## Fort Wayne Community Schools

High School Athletic Storage Buildings

### ADDENDUM #1

May 19, 2025

SHEET:  
**SSC203**

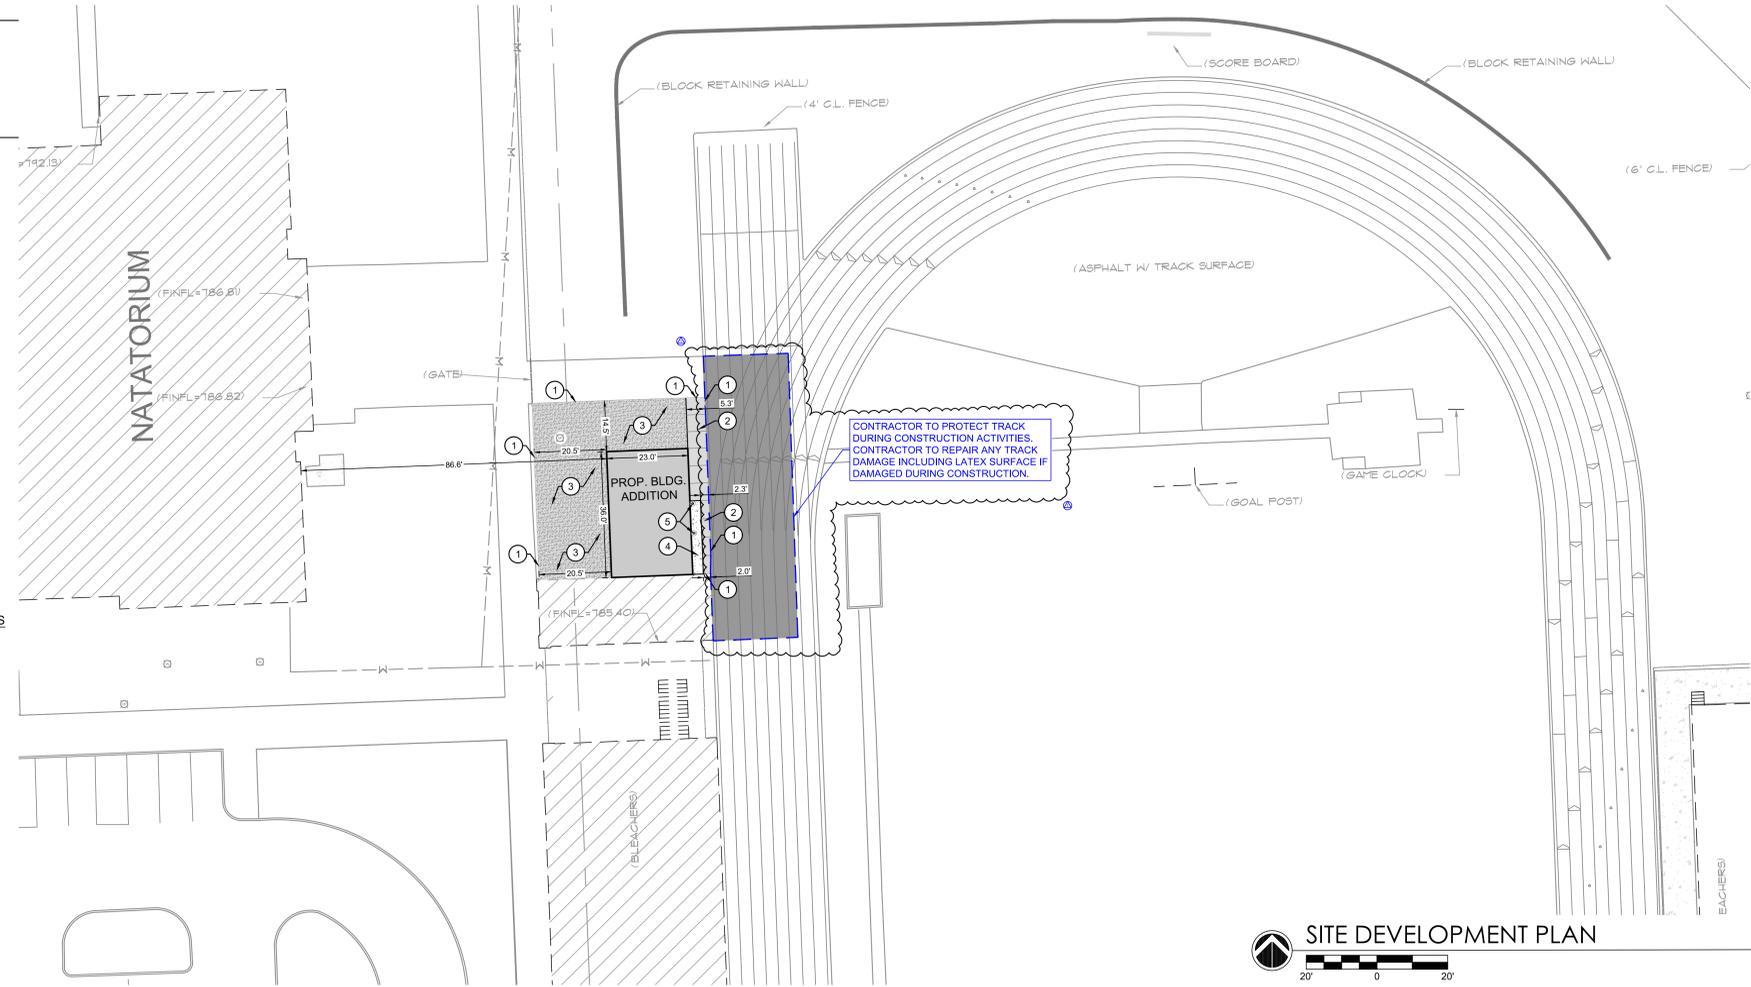
1. NRC301 – Site Erosion Control Plan – Northrop HS
  - a. Fix spelling in note about “ALLOW” gap in snow fence. No scope change.
2. NSC202 – Site Demolition Plan – North Side HS
  - a. See added tree removal.
3. SSC203 – Site Development Plan – South Side HS
  - a. The Contractor is responsible for protecting the existing track next to the proposed building and repairing any damage back to existing conditions. The Contractor must document existing conditions with photographs or video.

SHEET: **SSA103**  
COMM # 25007

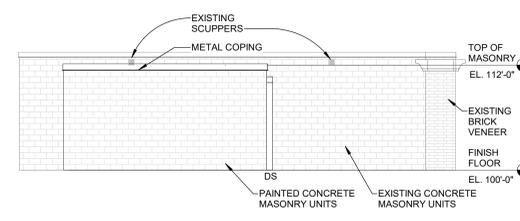
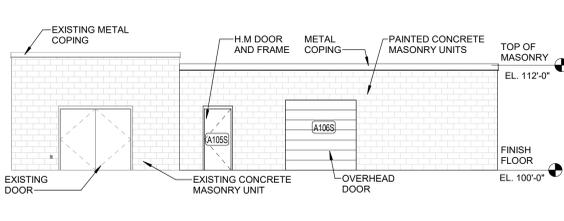
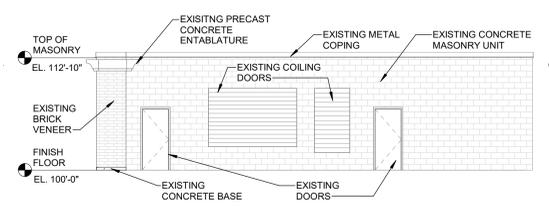
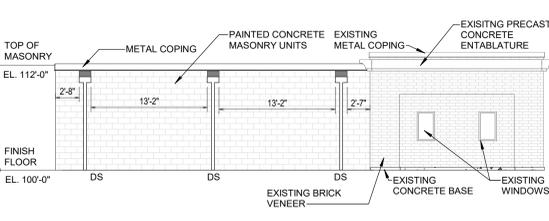
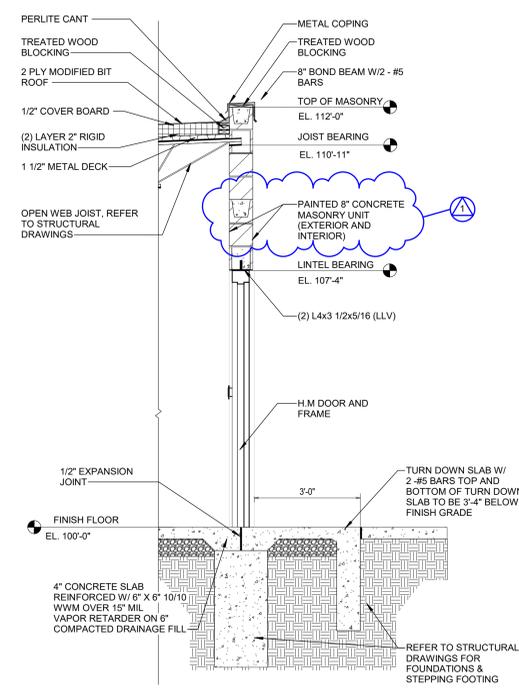
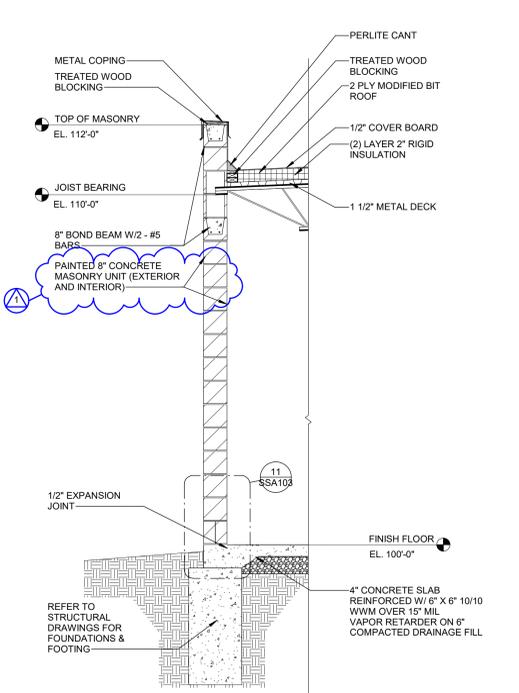
1. General Clarification. Sheets NRA101, NSA102, SSA103, WAA104--- have “NOT FOR CONSTRUCTION” over the stamp in error. This will be removed and replotted after bidding with construction set to be used for construction.
2. General Clarification:
  - a. At South Side High School, the steel roof deck and joists do not need to be painted.
3. Sheet SSA103 – Building Plans – South Side High School
  - a. Refer to updated drawing correcting downspout and splash block, and adding note to paint walls on interior and exterior of concrete masonry unit walls.

- 1 CONCRETE SPLASH BLOCK AT BASE OF DOWNSPOUT
- 2 PAINTED EXTERIOR AND INTERIOR OF CONCRETE MASONRY UNITS.
